Intersection ID: 17430	Main Street: W_WOODLAWN_RD	Cross Street: WALLINGFORD_ST	Location:	NW
ADA ID: 3648A68D1942	Ramp Type: PerpDiag	Initial Pass/Fail: Fail	Overall Compliance: No	Severity Score: 13.75

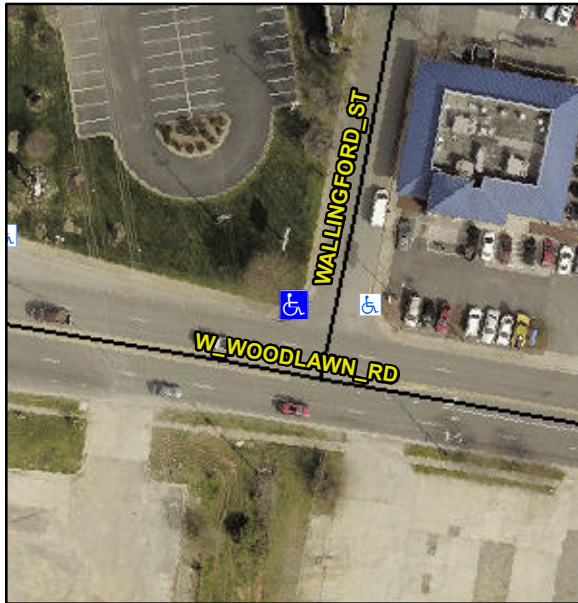
**Not Found, R304.2.2, R304.5.3**

Compliance	Description	Data	Compliance	Description	Data
N/A	Ramp Length (in)	60.0	No	Ramp Slope (%)	10.8
Yes	Ramp Width (in)	48.0	No	Ramp XSlope (%)	3.5
N/A	Flare Type LT	N/A	N/A	Flare Type RT	N/A
N/A	Flare Slope LT (%)	N/A	N/A	Flare Slope RT (%)	N/A
N/A	Flare Traversable LT?	N/A	N/A	Flare Traversable RT?	N/A
N/A	Landing Length (in)	N/A	N/A	DWS Provided?	N/A
N/A	Landing Width (in)	N/A	N/A	DWS Contrast?	N/A
N/A	Landing Slope (%)	N/A	N/A	DWS Length (in)	N/A
N/A	Landing X Slope (%)	N/A	N/A	DWS Full Width?	N/A
N/A	Landing Curb? (Y/N)	N/A	N/A	DWS Offset (in)	N/A
N/A	Shared Landing?	N/A			
N/A	Gutter Ponding?	N/A	N/A	Gutter Slope (%)	N/A
N/A	Gutter Lip Ht (in)	N/A	N/A	Gutter X Slope (%)	N/A
N/A	Painted X Walk1?	No	N/A	Painted X Walk2?	No
	X Walk 1 Direction	To SW		X Walk 2 Direction	To E
N/A	X Walk 1 Width (in)	N/A	N/A	X Walk 2 Width (in)	N/A
	X Walk 1 Slope (%)	1.4		X Walk 2 Slope (%)	0.4
	X Walk 1 X Slope (%)	0.2		X Walk 2 X Slope (%)	2.4

**Remove & Replace Curb Ramp With Two New Directional Ramps or Equivalent.**
